**ADDENDUM #5**

**Will County Health Department**  
**BID PACKAGE #2 – Misc. Steel/Structural/Enclosure**  
**November 15, 2018**

**SECTION 00 91 07  
BP #2 - ADDENDUM NUMBER 5**

**PROJECT:**           **WILL COUNTY HEALTH DEPARTMENT - NEW HEALTH DEPARTMENT  
BUILDING  
501 ELLA AVENUE  
JOLIET, ILLINOIS 60433**

**TYPICAL SLAB REINFORCING AT COLUMNS**  
SCALE: N.T.S.

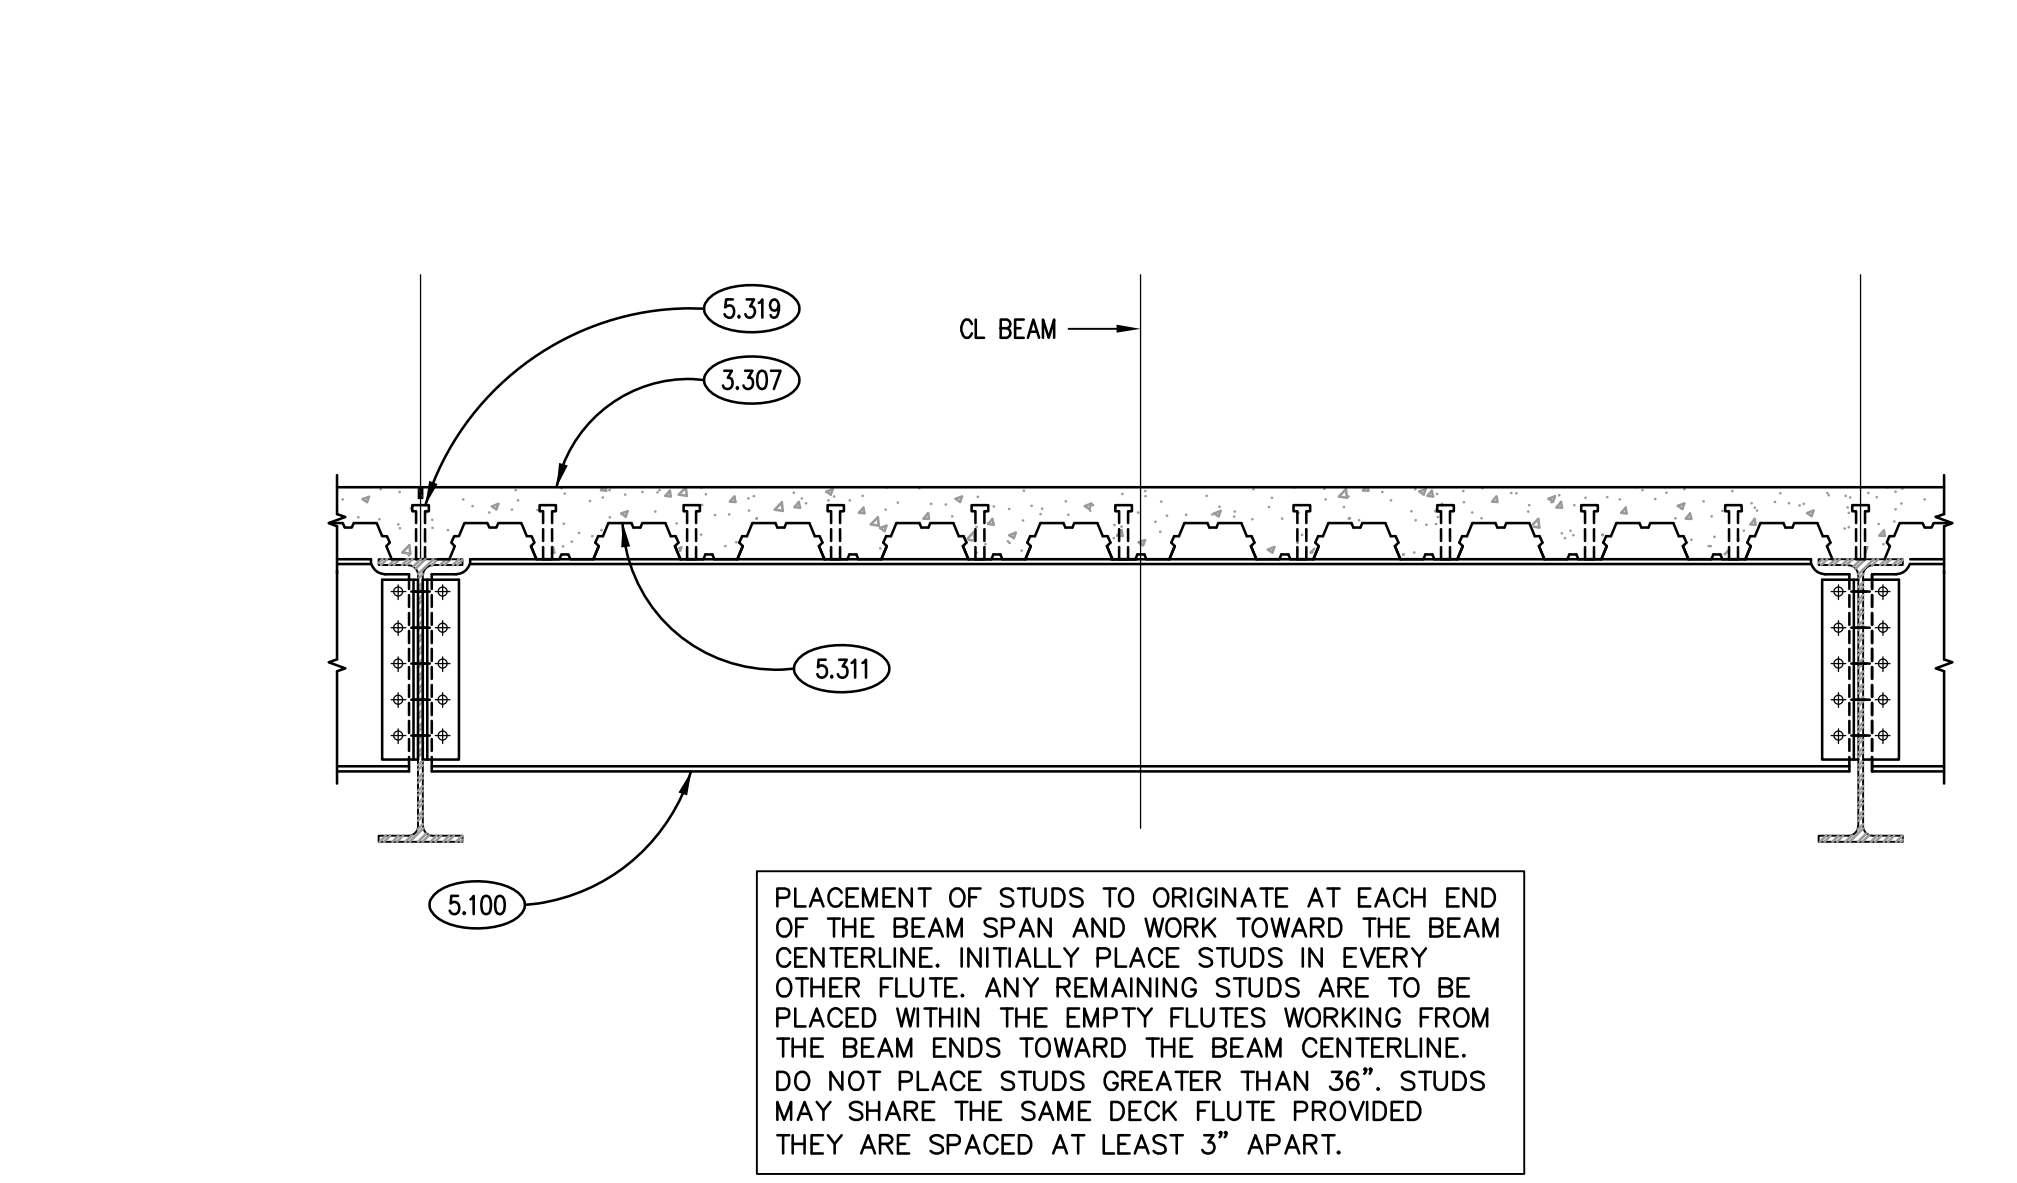
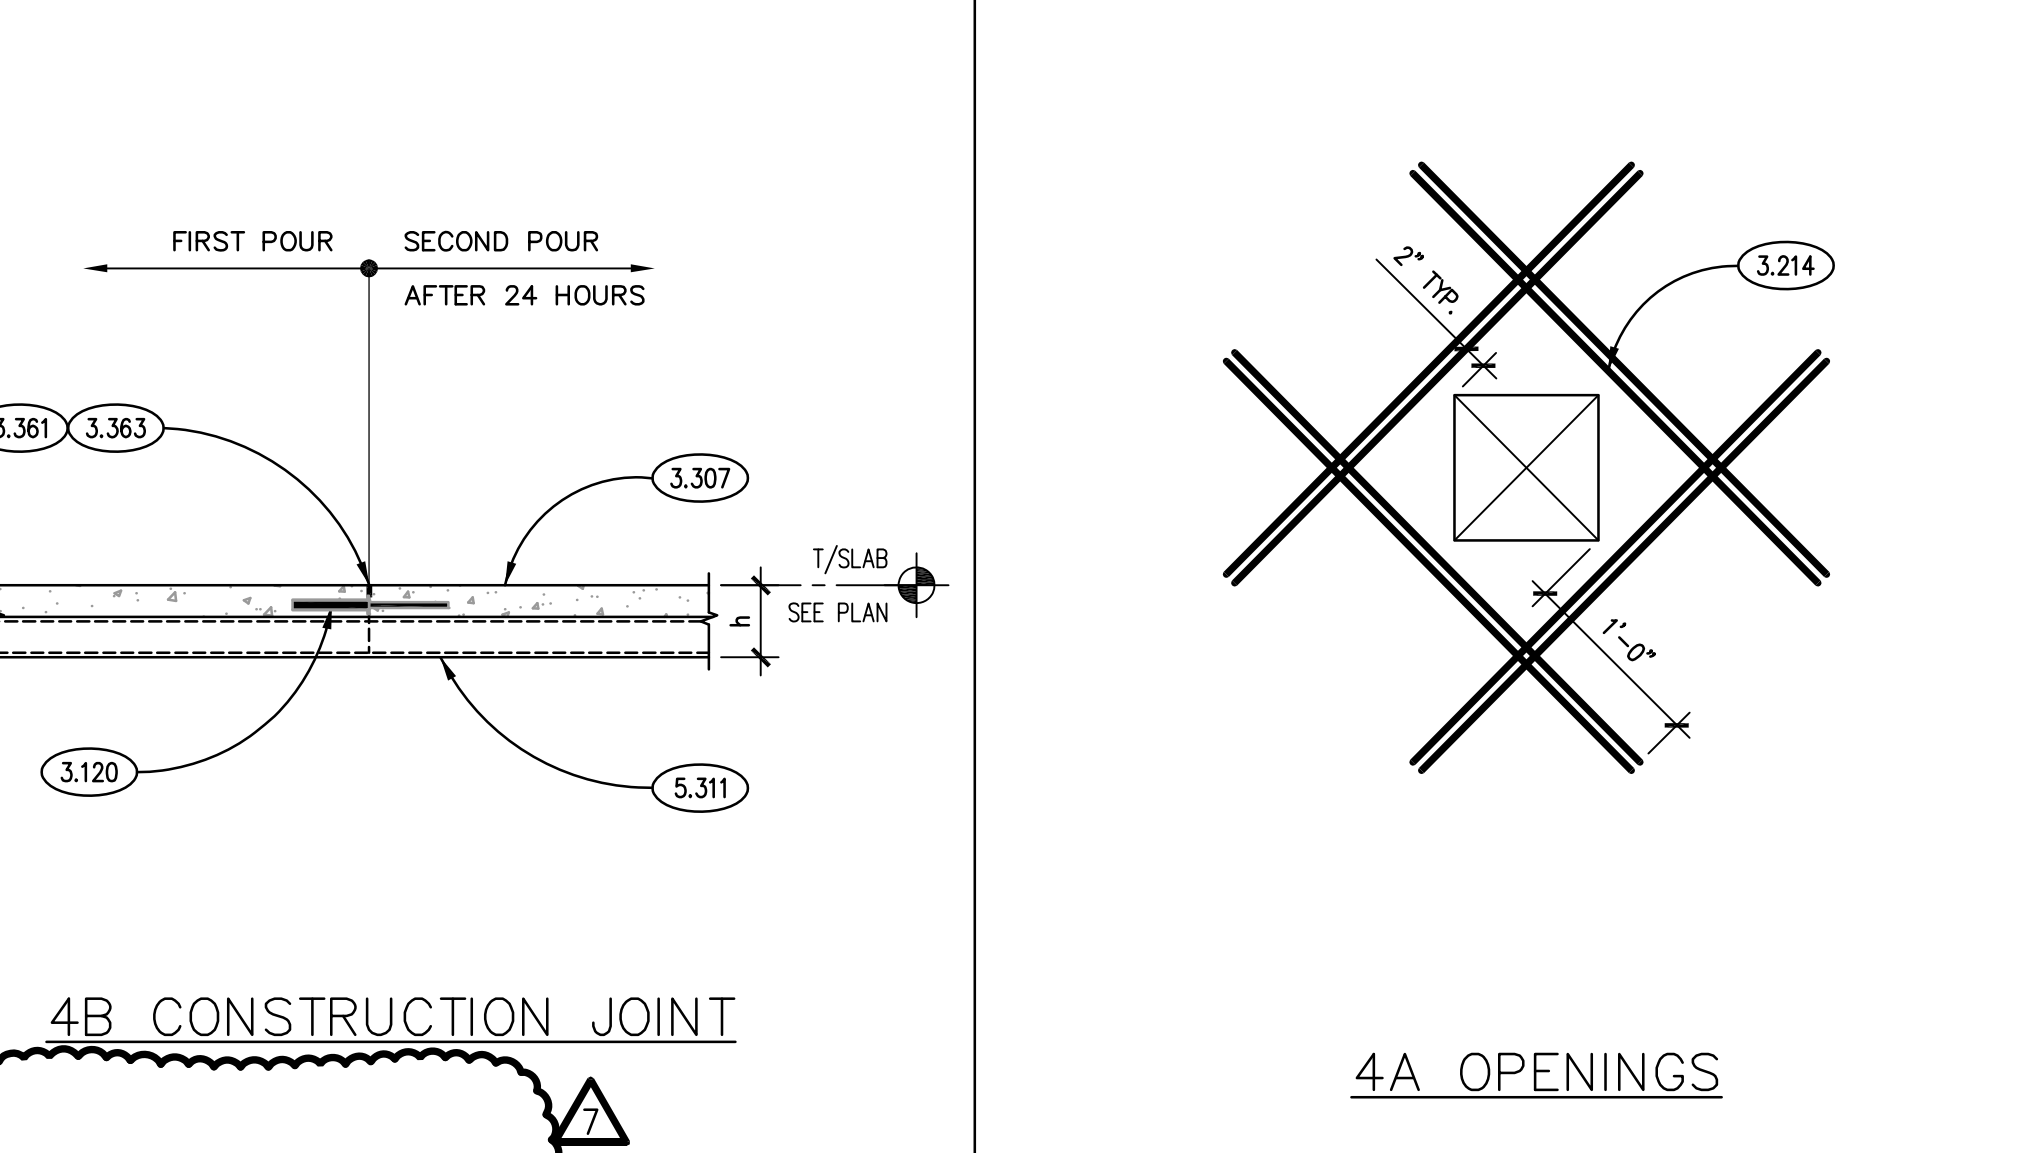
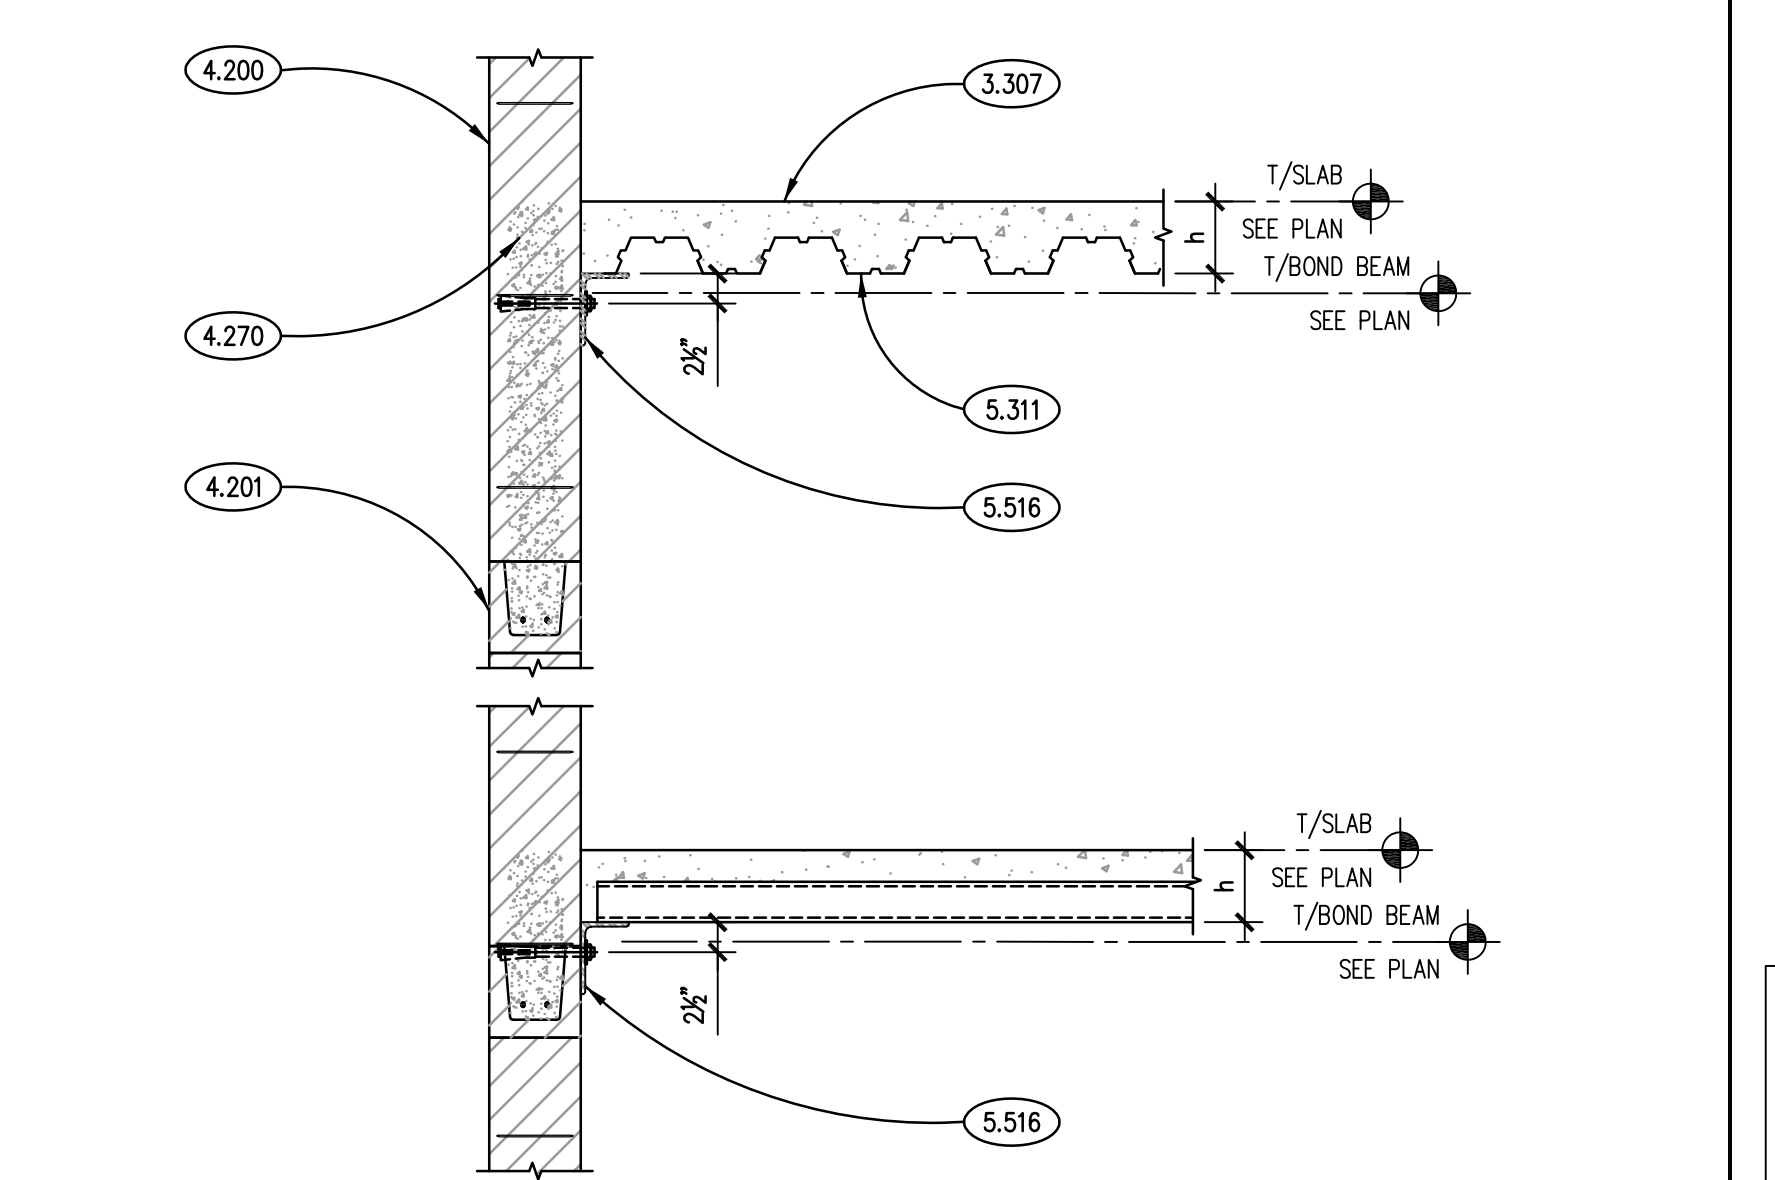
- A. Delete drawing in its entirety and replace with drawing number S500 (attached). Refer to revision cloud 9 for specific changes.
